Item ID: D206-642-341BL Accept ***N900040100*** Setup Start ***NS1***
Revision ID: Stop ***NS2***
Item Name: Replacement Skidtube (Fits LH or RH)
Start Date: 8/4/2017 Start Qty: 1.00 ***1*** Cust Item ID:
Required Date: 9/25/2017 Req'd Qty: 1.00 ***1*** Customer:
Reference:

DRAWING NO. D2650	TITLE 206/407 SKIDTUBE ASSEMBLIES	REV. F	DART AEROSPACE LTD ENGINEERING ORDER		D.E.O. NO. D2650-F-1	SHEET NO. SHEET 1 OF 1	SCALE NTS
DRAWN <i>[Signature]</i>	CHECKED A.P.	MFG. APPR. <i>[Signature]</i>	APPROVED <i>[Signature]</i>		DE APPR. <i>[Signature]</i>		
DATE 12.10.12	DATE 12.10.22	DATE 12.10.22	DATE 12.10.22		DATE 12.10.22

PURPOSE:

CHANGE C'BORED WELDED CROSSBOLT SPACERS TO SWAGED SPACERS

DETAIL B

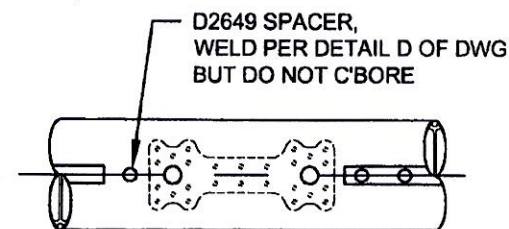
ADD DETAIL G BELOW, WHICH IS THE SAME SECTION VIEW AS DETAIL D OF DWG.

C'BORED HOLES ARE NOW SWAGED PER DETAIL G BELOW. FOR THE Ø0.375 HOLE THAT IS NOT C'BORED, WELD PER DETAIL D OF DWG (SEE AMENDED DETAIL B FOR REFERENCE).

DETAIL G

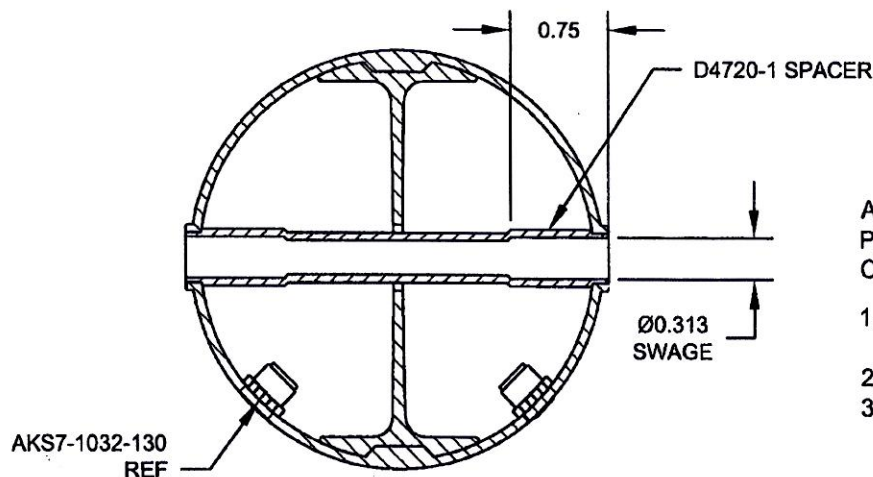
AFTER DRILLING AND BENDING ASSEMBLY
PERFORM THE FOLLOWING FOR Ø0.375 HOLES THAT ARE
CURRENTLY C'BORED:

1. INSERT D4720-1 SPACER, 16 PL (-1) OR 17 PL (-3)
OR 19 PL (-5) OR 23 PL (-7)
2. SWAGE TO Ø0.313 X 0.75 DP PER QSI 002
3. TRIM / GRIND FLUSH PER QSI 002
